JRPP No:	2011SYE036
DA No:	DA.114/11
PROPOSED DEVELOPMENT	Demolition of part of existing structures including three dwellings and construction of a new dwelling over 3 levels including basement garage with car lift, inclinor and landscaping at 16–20 Lodge Road Cremorne
APPLICANT:	Leda Holdings Pty Ltd
REPORT BY:	Geoff Mossemeneer, Executive Planner, North Sydney Council

Addendum Report

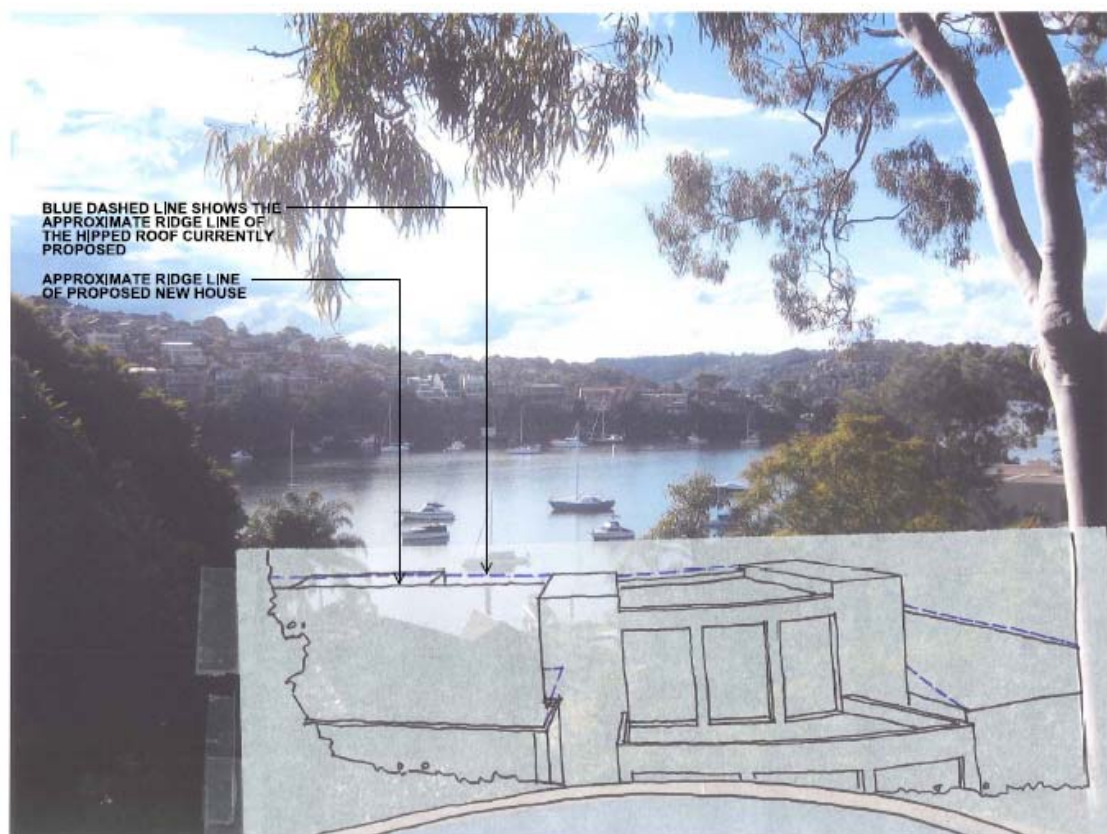
The applicant considered that viewpoint 1 and 2 provided the most expansive views and concentrated the modeling on those points. The applicant provided the following sections through the viewpoints:

- The northern eave of the roof to be lowered by 400mm to RL 12.3
- The ridge of the roof to be lowered by 1.167m (being 767mm from section for viewpoint 2 plus 400mm for lowering of roof eave) to RL 14.288 (this still allows a pitch of around 7-8° that is suitable for a metal/copper roof)
- The vergola roof over the northern balcony on level 3 being setback in line with the rest of the balcony and the height of the roof not to exceed RL 12.3 – The column detail to remain to provide some articulation to northern façade
- The lift overrun/plant room/entrance foyer roof not exceeding the ridge height of RL 14.288

SKETCH OVERLAY SHOWING APPROXIMATE IMPACT OF A FLAT ROOF FORM ON VIEW FROM VIEWPOINT 1.

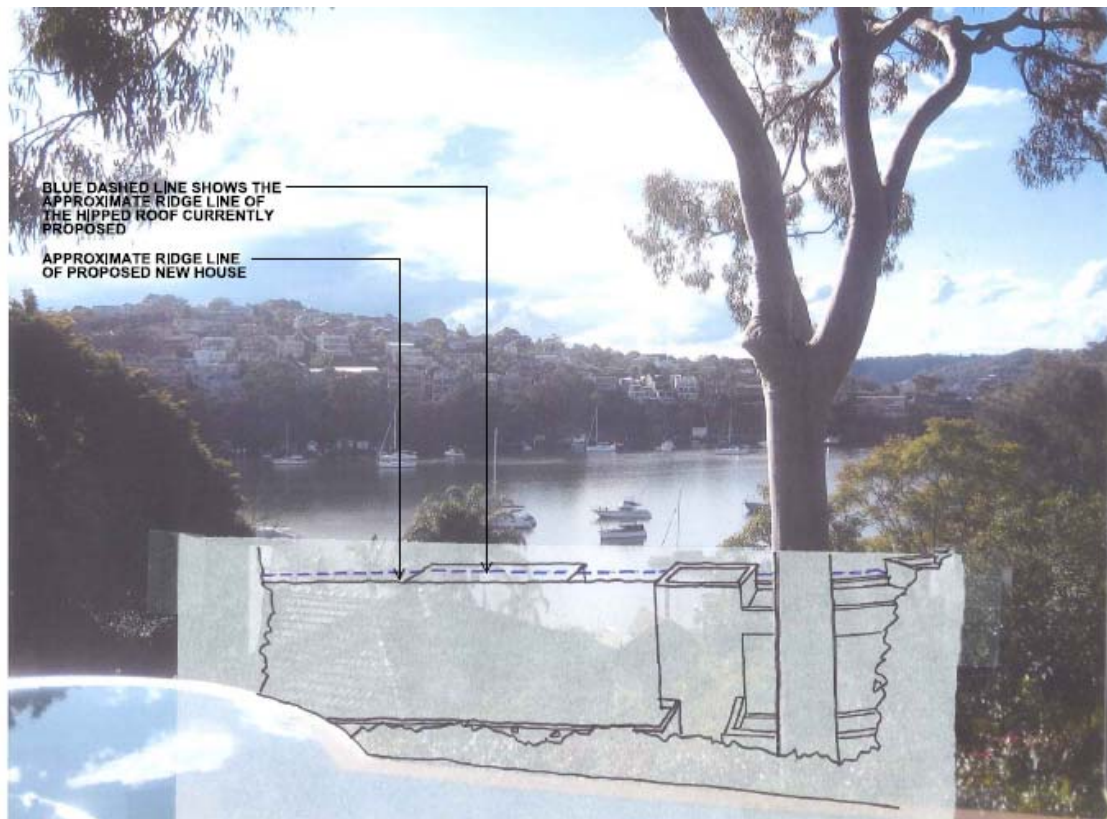
Even the difference between the pitched roof view line and the flat roof view line is significant, or at the very least 'moderate', in terms of reducing the close water views from the pool terrace level of 22 Lodge Rd.

The proposal as submitted is definitely acceptable from the upper two levels of 22 Lodge Road with regard to view impact. The middle living area level is acceptable and in accordance with the Panel's previous resolution for the first proposal. The neighbours are concerned with the views from the lowest level from the pool terrace. The overlays above indicate a loss of the foreshore

area that was partly visible and some water close to the foreshore. The majority of the water view is retained along with the moored boats and the opposite foreshore. The view is across the length of the site and from a lower level that is not considered the principal living area. The view impact is considered minor.

The parts of the building that affect the view are the northern eave of the roof, the ridge of the roof, the vergola roof over the balcony, the lift overrun/plant room/entrance foyer. All of these elements can be lowered/modified to minimise the impact to about half of that shown on the overlays and then the view impact would be classified as negligible:

- The northern eave of the roof to be lowered by 400mm to RL 12.3
- The ridge of the roof to be lowered by 1.167m to RL 14.288
- The vergola roof over the northern balcony on level 3 being setback in line with the rest of the balcony and the height of the roof not to exceed RL 12.3 – The column detail to remain to provide some articulation to northern façade
- The lift overrun/plant room/entrance foyer roof not exceeding the ridge height of RL 14.288
